CITY PLAN COMMISSION**THURSDAY, FEBRUARY 1, 2024****FILE NUMBER:** S234-043**SENIOR PLANNER:** Hema Sharma**LOCATION:** between Rhoda Lane and Elam Road, east of St. Augustine Drive**DATE FILED:** January 4, 2024**ZONING:** R-7.5(A)**CITY COUNCIL DISTRICT:** 5**SIZE OF REQUEST:** 7.109-acres**APPLICANT/OWNER:** Dallas Area Habitat for Humanity, Inc.

REQUEST: An application to replat a 7.109-acre tract of land containing all of Lots 6, 7, 8 and 9 in City Block A/6671 and part of City Block 6670 to create 27 lots ranging in size from 7,506 square feet to 9,332 square feet on property located between Rhoda Lane and Elam Road, east of St. Augustine Drive.

PRELIMINARY PLAT

ELAM ADDITION

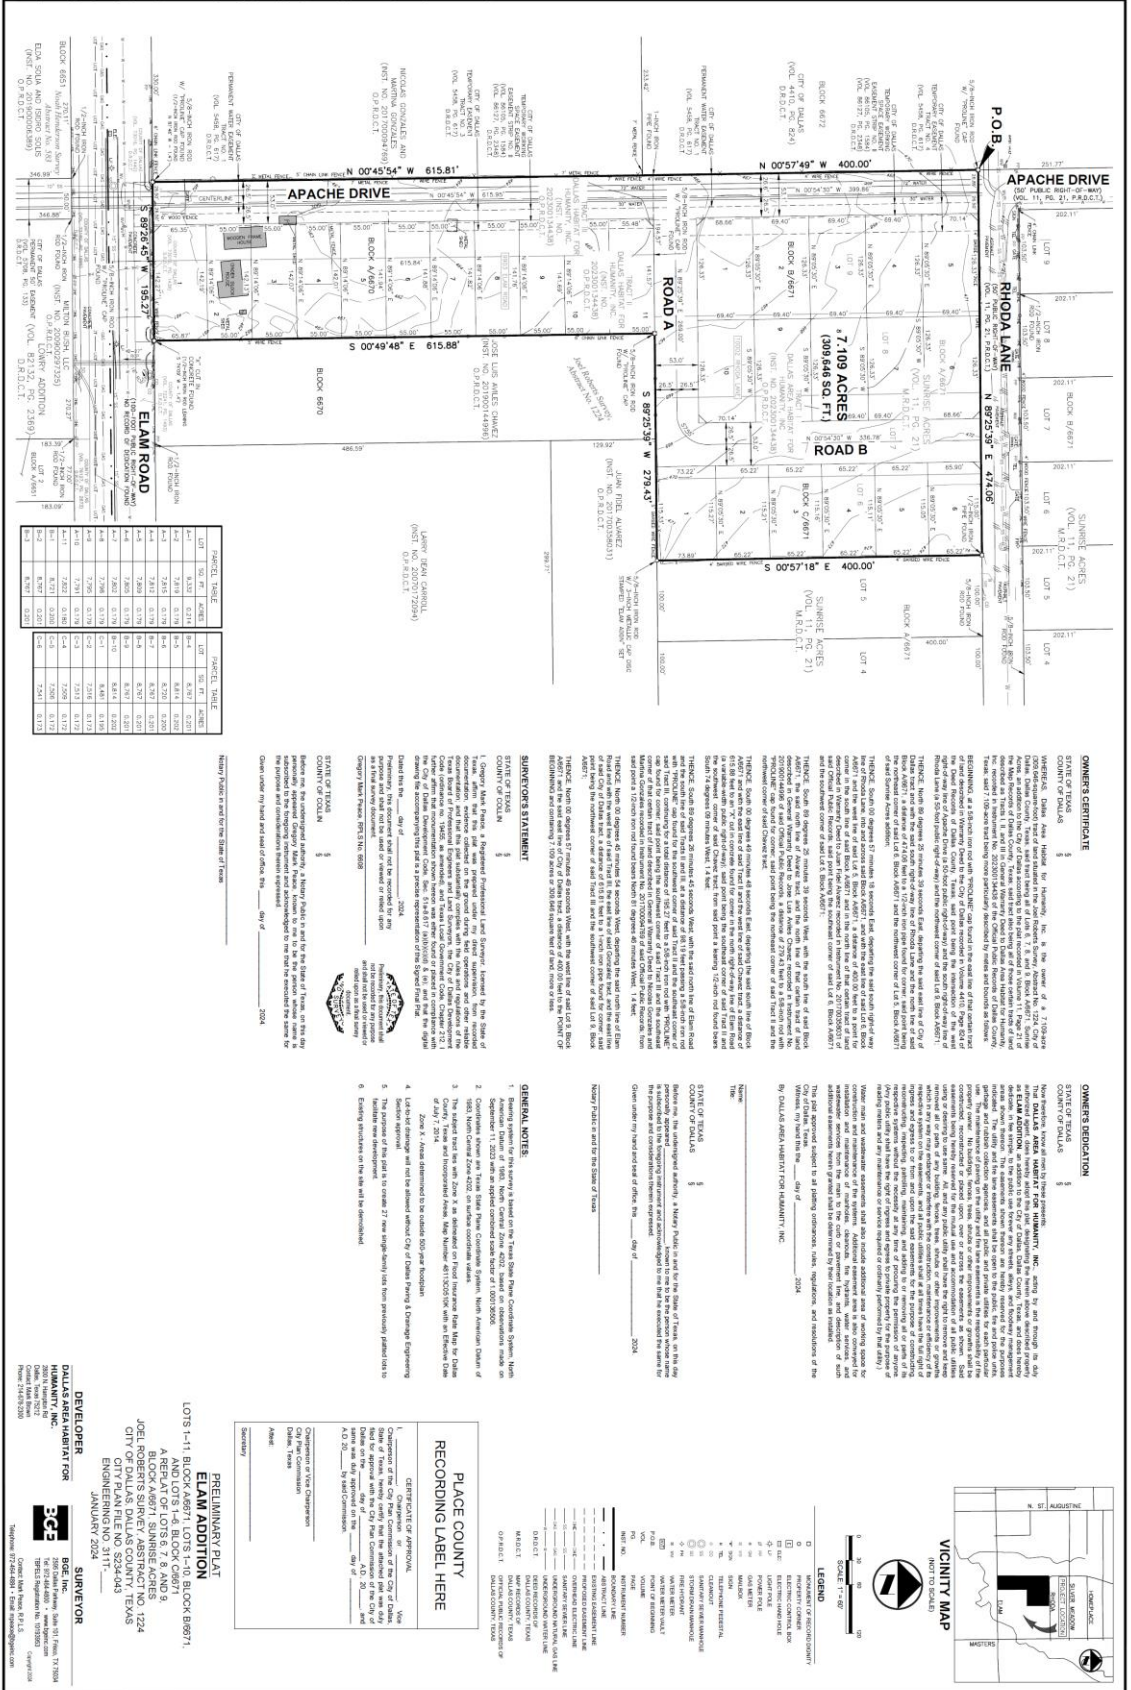
15. On the final plat, dedicate 50 feet of right-of-way (via fee simple) from the established center line of Elam Road. *Section 51A 8.602(c)*
16. On the final plat, dedicate 28 feet of right-of-way (via fee simple or street easement) from the established centerline of Rhoda Lane. *Sections 51A-8.602(c), 51A-8.604(c) and 51A-8.611(c).*

17. On the final plat, dedicate a minimum 10-foot by 10-foot corner clip (via fee simple or street easement) at the intersection of Elam Road & Apache Drive. Section 51A 8.602(d)(1).

18. On the final plat, dedicate a minimum 5-foot by 5-foot corner clip (via fee simple or street easement) at the intersection of Apache Drive & Road A. Section 51A 8.602(d)(1).

19. On the final plat, dedicate a minimum 5-foot by 5-foot corner clip (via fee simple or street easement) at the intersection of Road A & Road B. Section 51A 8.602(d)(1).

20. On the final plat, dedicate a minimum 5-foot by 5-foot corner clip (via fee simple or street easement) at the intersection of Road B & Rhoda Lane. Section 51A 8.602(d)(1).

22. Prior to final plat, submit a completed final plat checklist and all supporting documents.
23. On the final plat, chose a new or different addition name.
24. On the final plat, show abstract line location.

29. Prior to the final plat, please remove structures encroaching on Right-of Way Dedication.
30. On the final plat, change "Apache Drive" to "Apache Drive (FKA Rhoda Lane)".
31. On the final plat, change "Rhoda Lane" to "Rhoda Lane (FKA Apache Drive)".
32. Contact addressing team for appropriate names for "Road A" and "Road B".
33. On the final plat, identify the property as Lots 1 through 11 in City Block A/6670, Lots 1 through 10 in City Block B/6670, Lots 1 through 6 in City Block C/6670.
